Reference: Engineering Services
80 Sweetwater Ln.
Broadway, NC 27505
TE&D Project No.: 2401-020343

- 1) Analysis of the existing unpermitted addition with regards to the 2018 North Carolina Residential Building Code.
- 2) Analysis of porch framing to support proposed 4" thick concrete slab.

Structure Analyzed

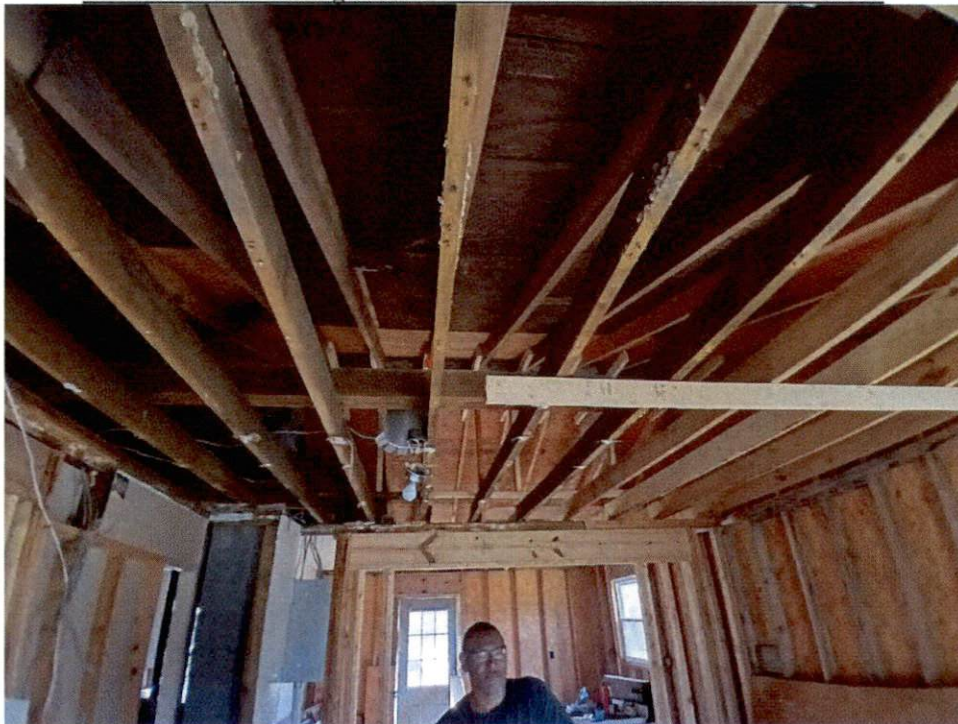
All Rafters and Ceiling Joists Over Center of Addition to be Enhanced

Porch Analyzed

- a. The existing 2 x 6 joists at 16" o.c. over the addition are to be enhanced to minimum (2) 2 x 6 joists at 16" o.c.

- b. The existing 2 x 6 rafters over the center of the addition are to be enhanced to a minimum of (2) 2 x 6 rafters at 16"o.c.
